MPWR-LTR-12-00101

Babcock & Wilcox mPower, Inc.  
Docket Number-PROJ0776  
Project Number-776

Subject: Submittal of Babcock and Wilcox mPower, Inc. (B&W mPower) Instrument Setpoint  
Methodology Topical Report R0003-08-002089-A, Revision 003

**Figure 5.1: Setpoint Relationships – For Increasing Setpoint (Similar for decreasing setpoint, but process is decreasing towards the setpoint).**

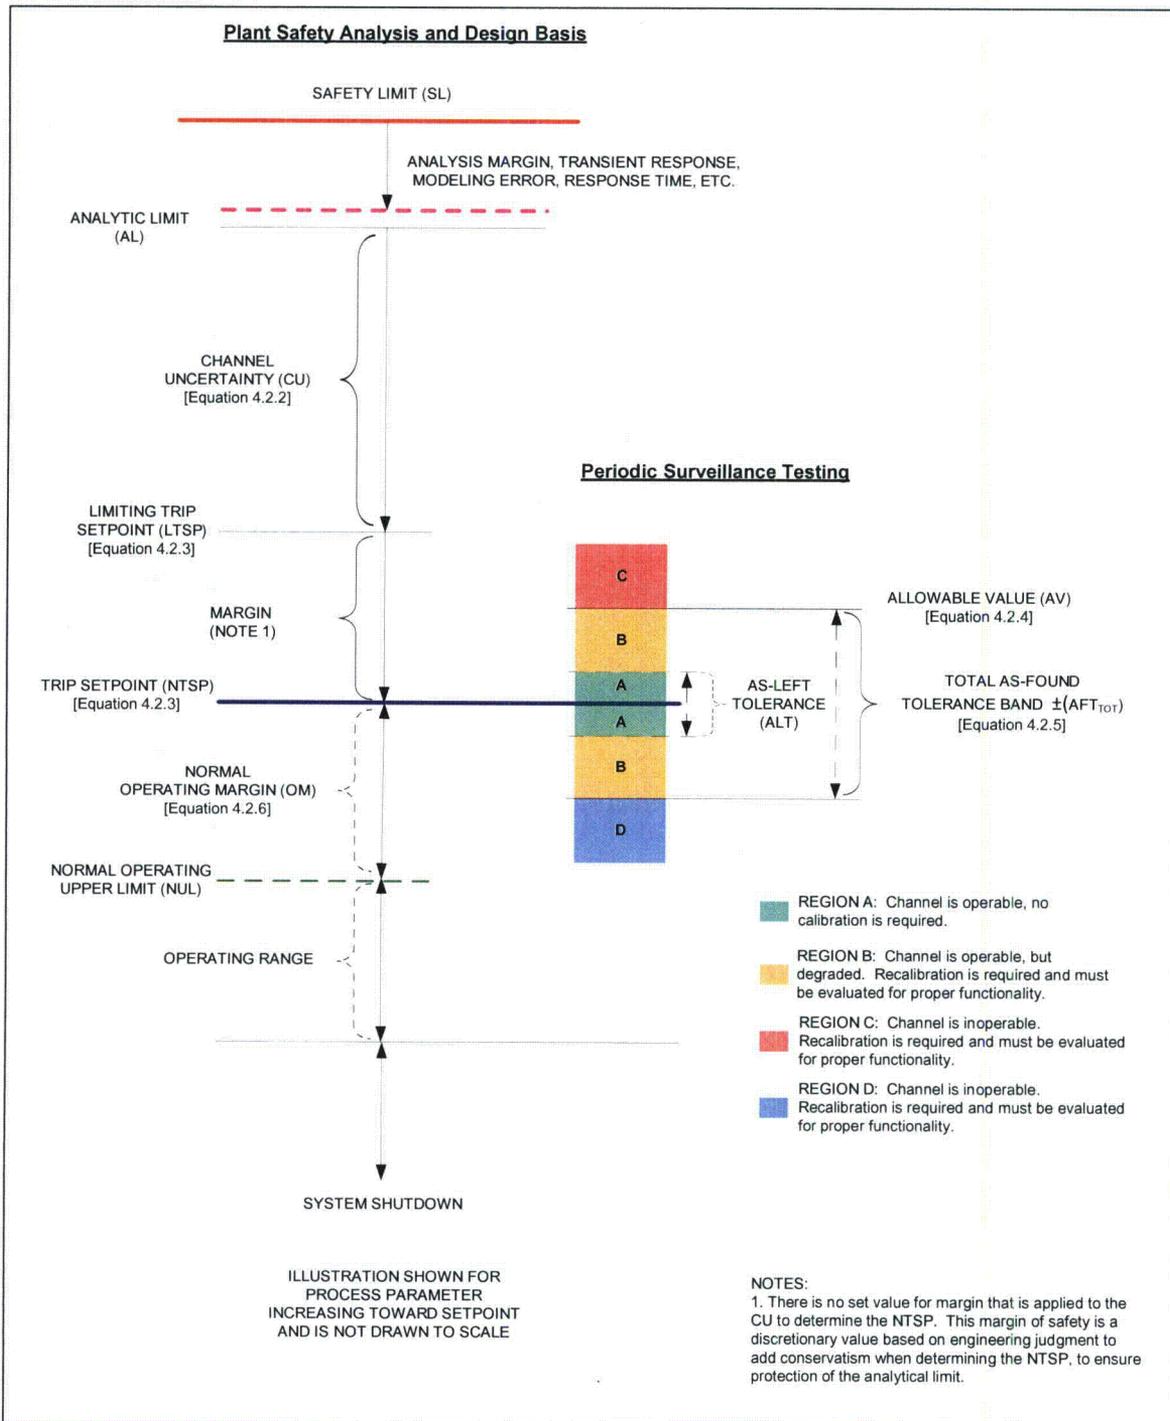
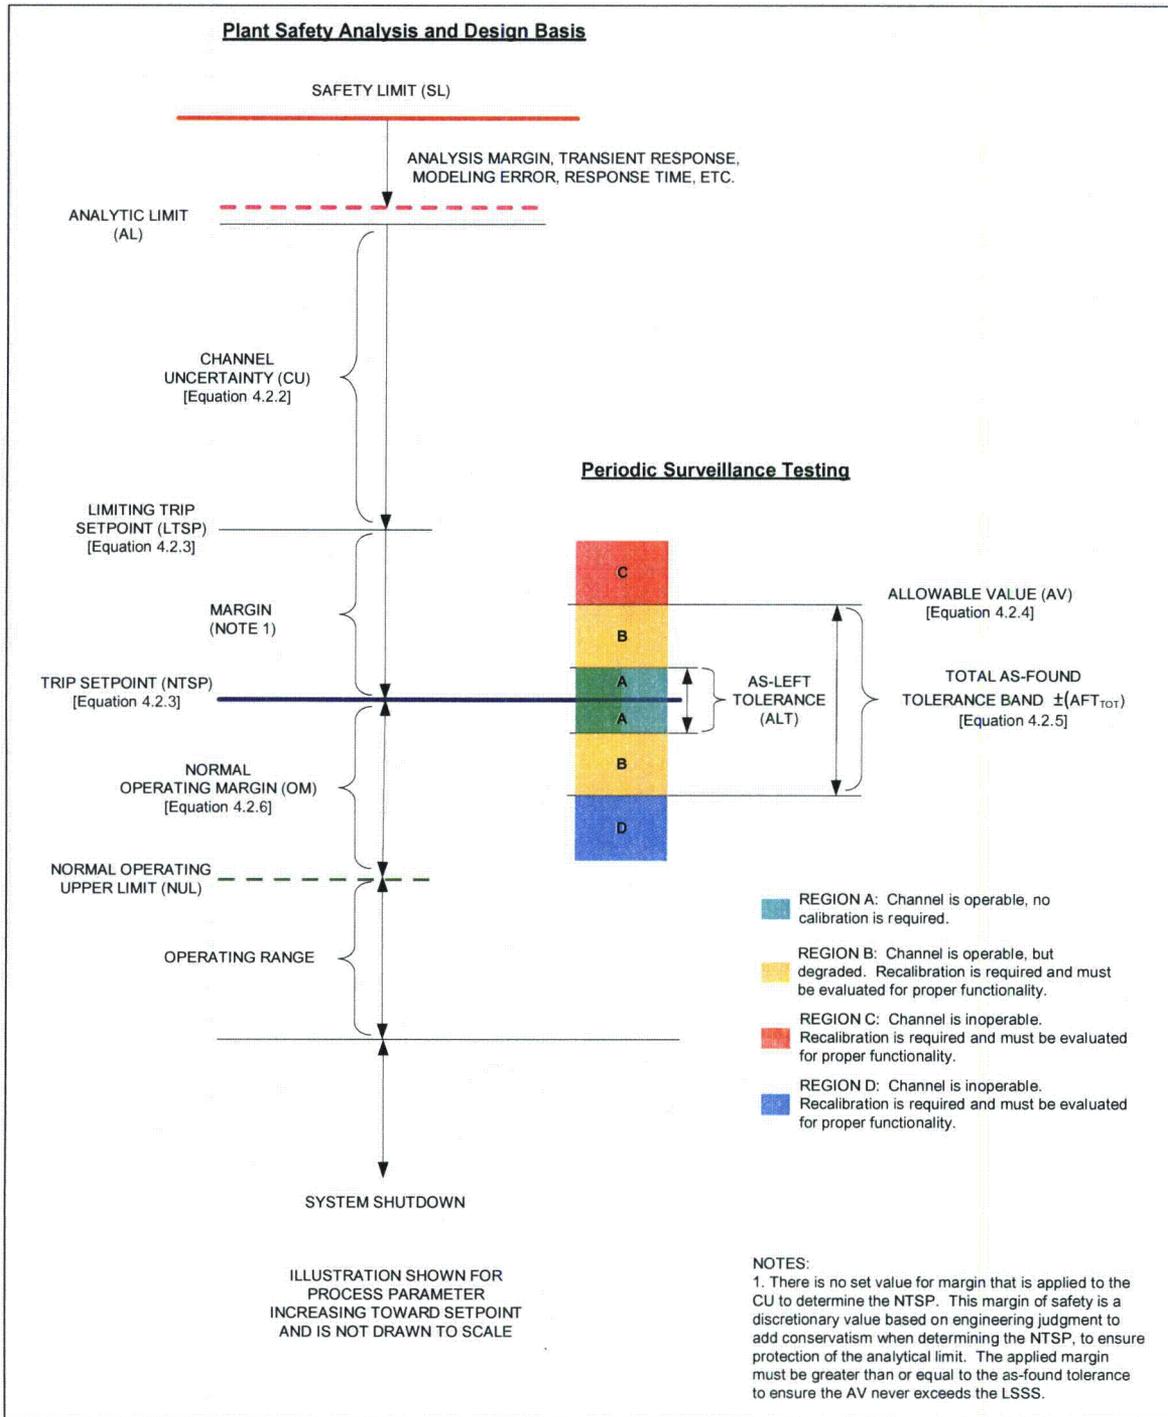
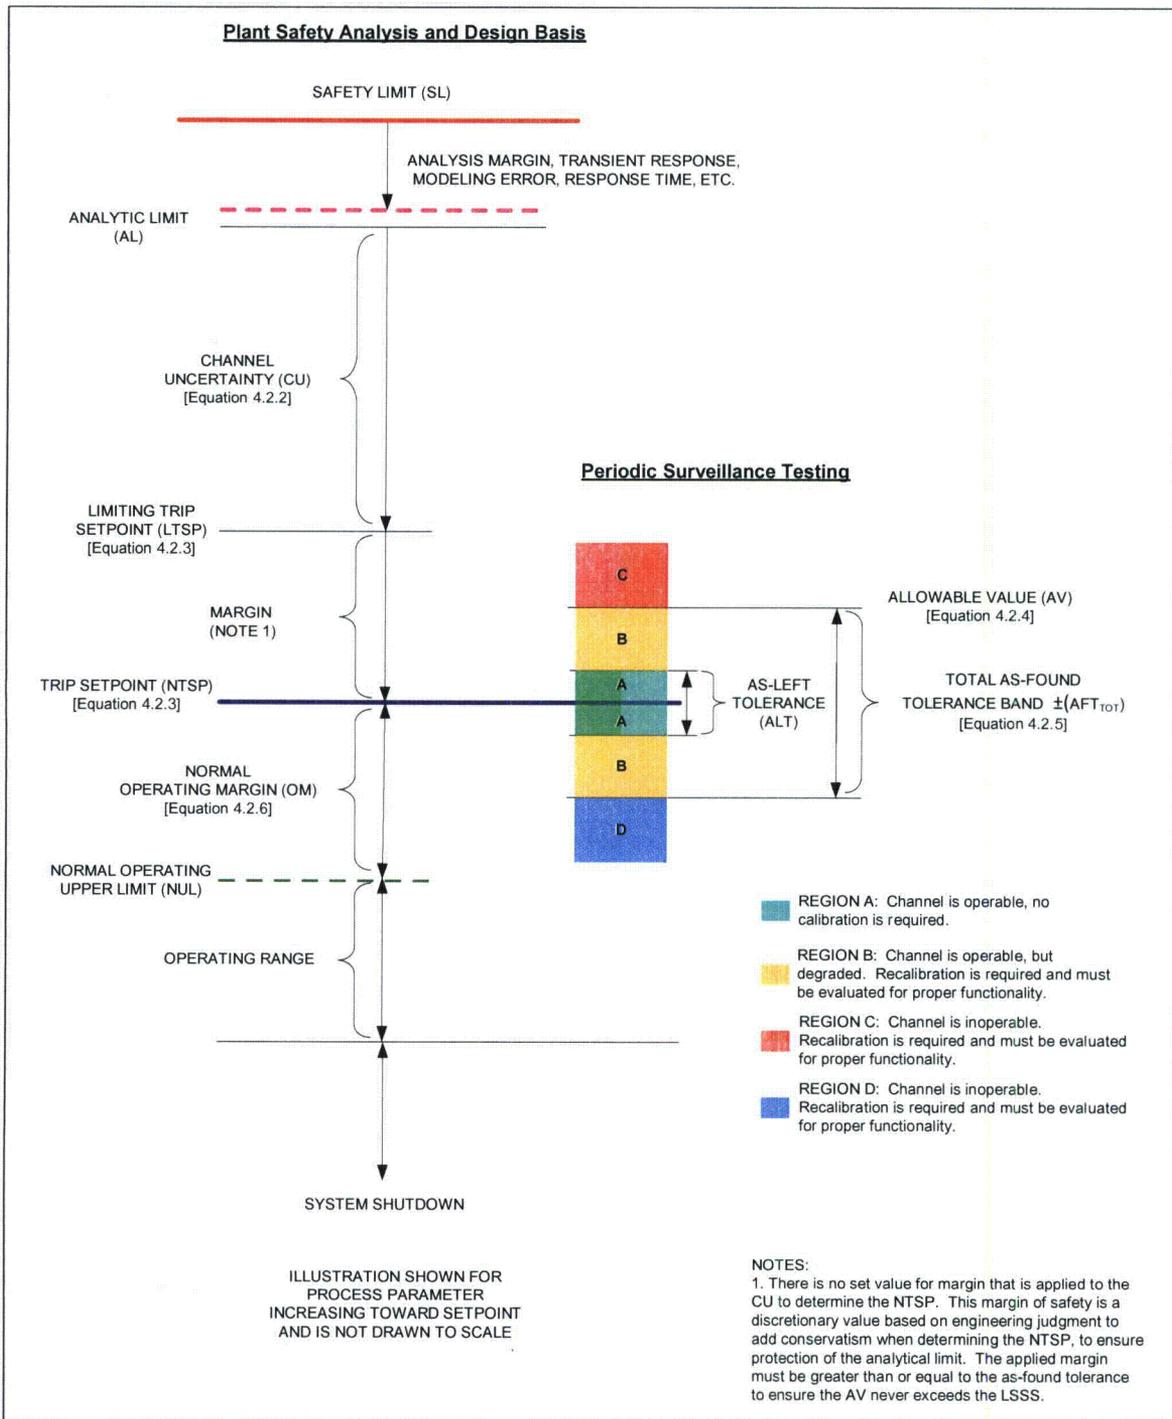
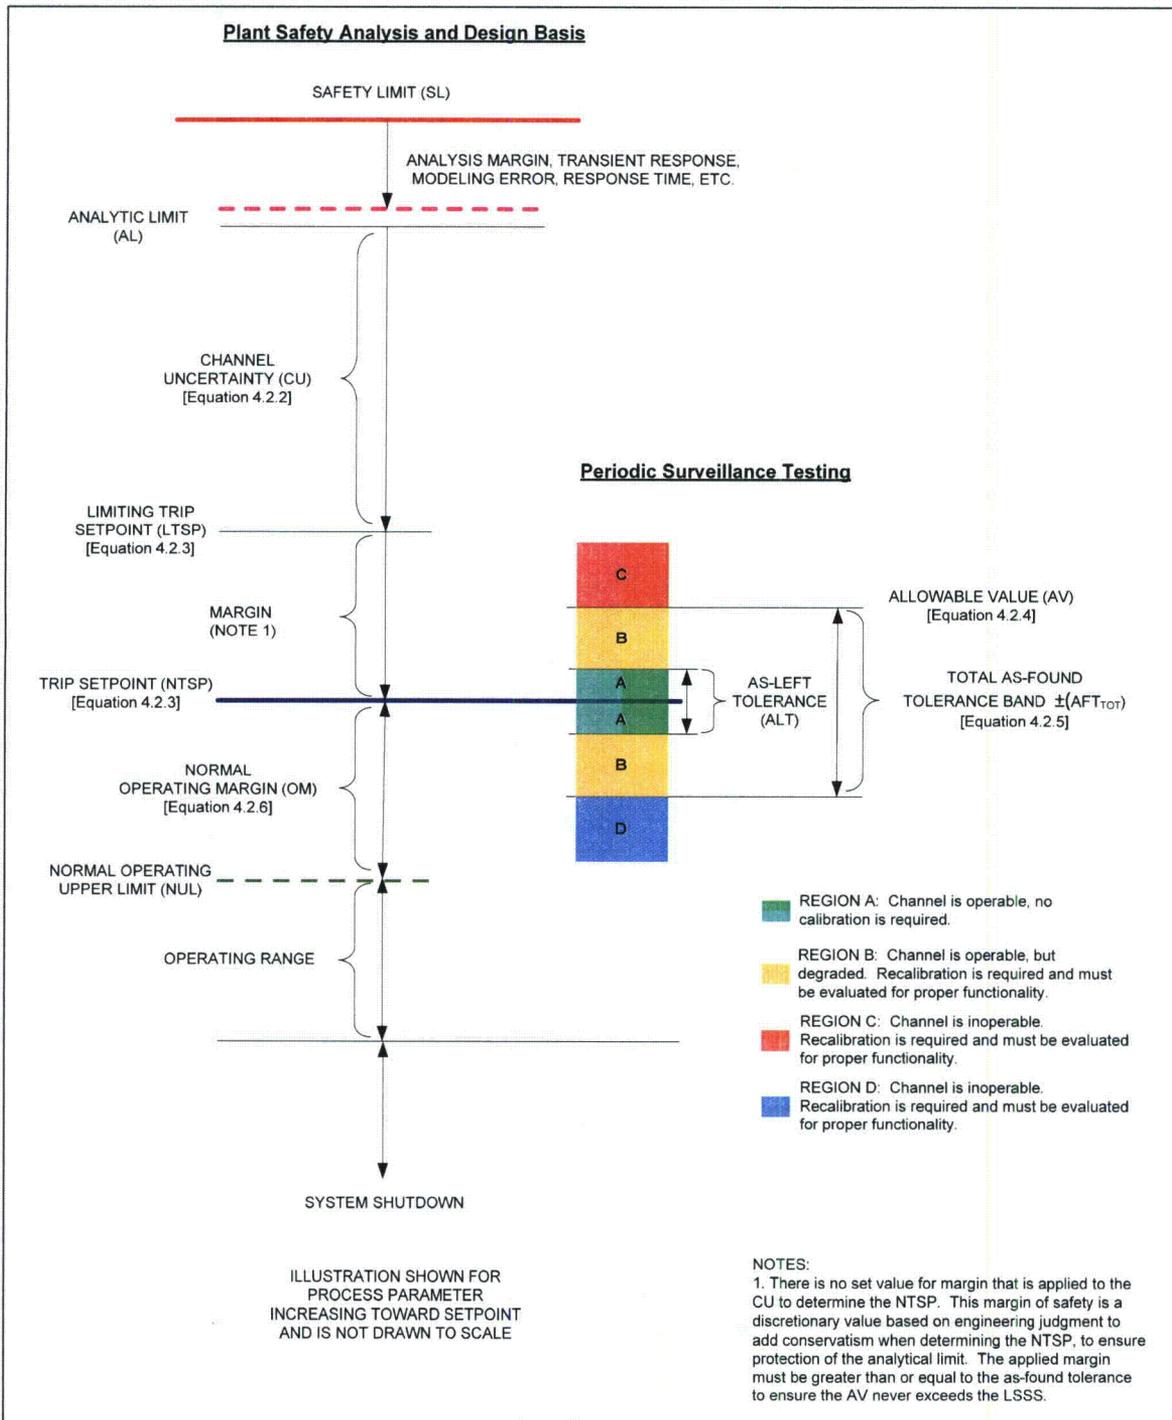
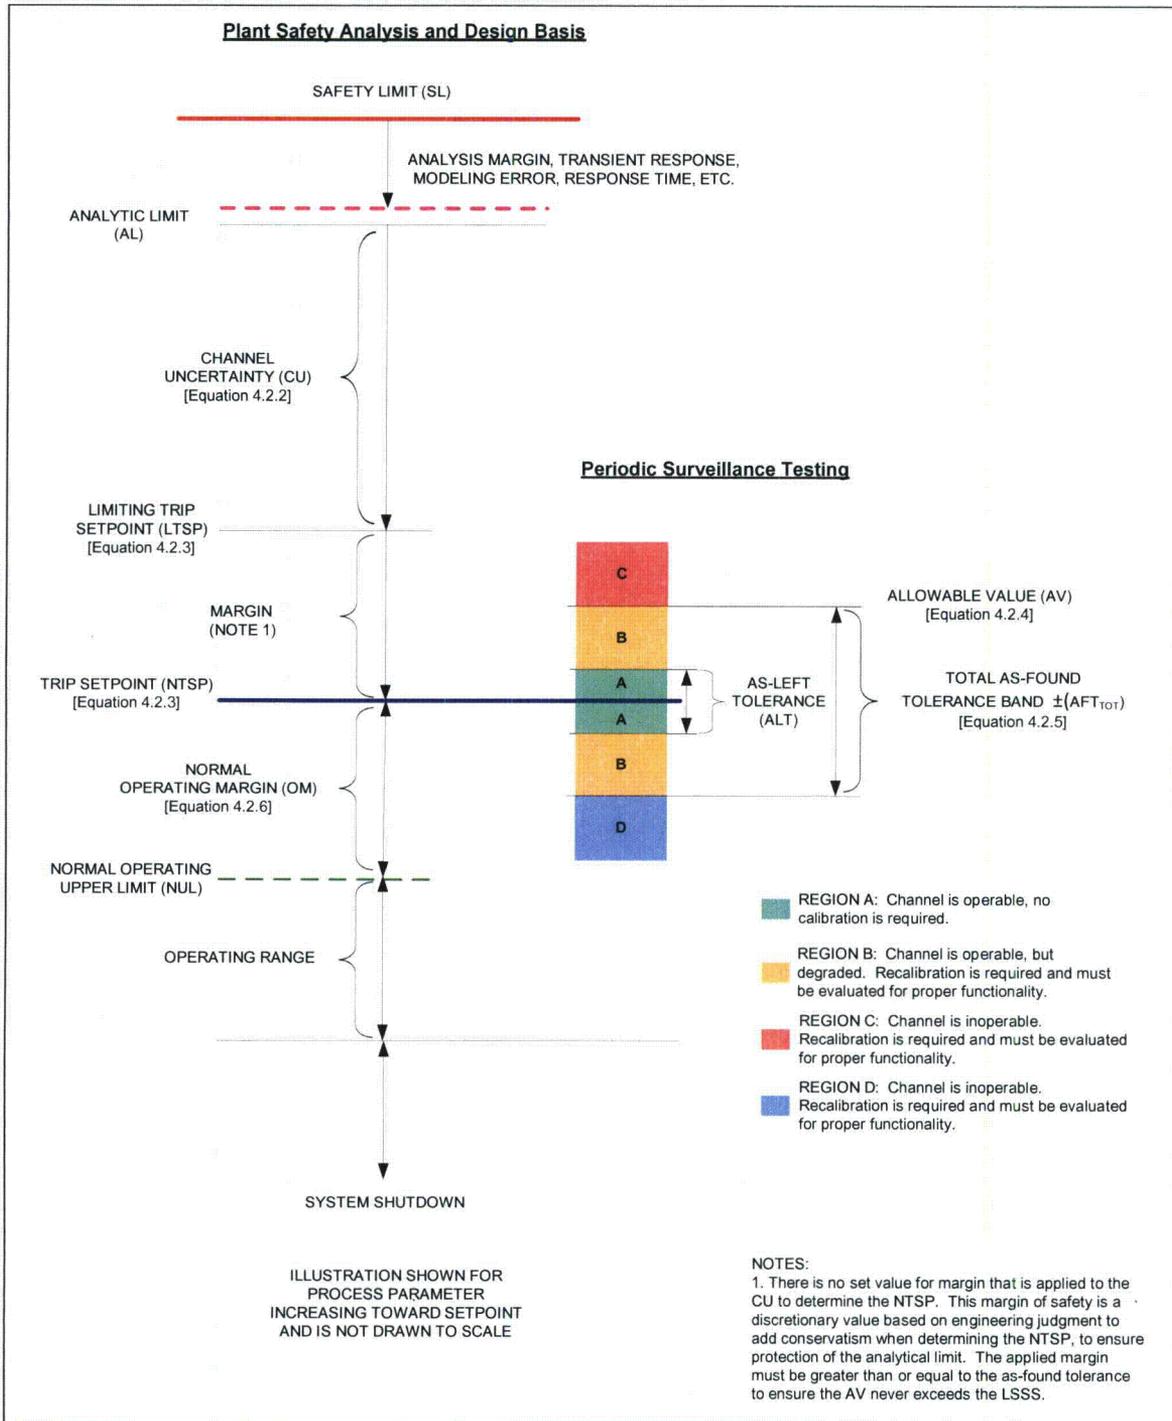
**Figure 5.1** - This figure shows Margin (Note 2) added to the setpoint calculation. The staff requests that the applicant clarify the use of margin in the figure and revise the figure to reflect both the +/- of AFT, ALT, and the location of Margin (Note 2) in relationship to NTSP, AFT and AV (see below).

**Sections 4.2.4, 4.2.5 and Figure 5.1:**

- Section 4.2.4 - How is  $AFT^{TOT}$  calculated as a +/- value and shown on both sides of NTSP on Figure 5.1?
- Section 4.2.5 - How is  $AFT_n$  calculated as a +/- value?
- Section 4.2.4 - Explain why the definition of Margin is different from Note 2 on Figure 5.1.
- Is Margin (Note 2) correctly shown on Figure 5.1? see bullet 1 above.
- What value of ALT would be used in Figure 5.1? (Refer to RG 1.105 Rev. 3 Figure 1, "E. Region of Calibration Tolerance")

**Sections 4.2.4, 4.2.5 and Figure 5.1:**

- Section 4.2.4 - How is  $AFT^{TOT}$  calculated as a +/- value and shown on both sides of NTSP on Figure 5.1?
- Section 4.2.5 - How is  $AFT_n$  calculated as a +/- value?
- Section 4.2.4 - Explain why the definition of Margin is different from Note 2 on Figure 5.1.
- Is Margin (Note 2) correctly shown on Figure 5.1? see bullet 1 above.
- What value of ALT would be used in Figure 5.1? (Refer to RG 1.105 Rev. 3 Figure 1, "E. Region of Calibration Tolerance")

To clarify the relationship between Margin and NTSP, AFT and AV a number of changes will be made to Figure 5.1 and the text contained in Sections 4.2.4 and 4.2.5 of the topical report.

Figure 5.1 will be updated to properly illustrate the application of a double-sided band for the AFT<sub>TOT</sub> as applied to the NTSP to ensure consistency with revisions to equation 4.2.4 described above. Additional revisions and enhancements to Figure 5.1 (page 24) include the following and the revised figure is shown below:

- Addition of a double-sided band for the ALT to aid in determination of channel operability and be consistent with Figure 1 in RG. 1.105.
- Illustration of regions of different conditions that may exist during periodic surveillance testing to clarify status of channel operability and required actions (if any).
- Removal of the margin applied to the AFT<sub>TOT</sub> and its associated note (Note 2). (To protect against the potential for masking of equipment degradation during periodic surveillance testing.)

Figure 5.1 has been updated to properly illustrate the application of a double-sided band for the AFT<sub>TOT</sub> as applied to the NTSP to ensure consistency with revisions to equation 4.2.4 described above. Additional revisions and enhancements to Figure 5.1 (page 24) include the following bulleted items. The revised figure is shown on the following page.

- Addition of a double-sided band for the ALT to aid in determination of channel operability and be consistent with Figure 1 in RG. 1.105.
- Illustration of regions of different conditions that may exist during periodic surveillance testing to clarify status of channel operability and required actions (if any).
- Removal of the margin applied to the AFT<sub>TOT</sub> and its associated note (Note 2). (To protect against the potential for masking of equipment degradation during periodic surveillance testing.)
- Identification that the margin must be greater than or equal to AFT<sub>TOT</sub> to ensure the AV remains less than or equal to the LSSS (Note 1).
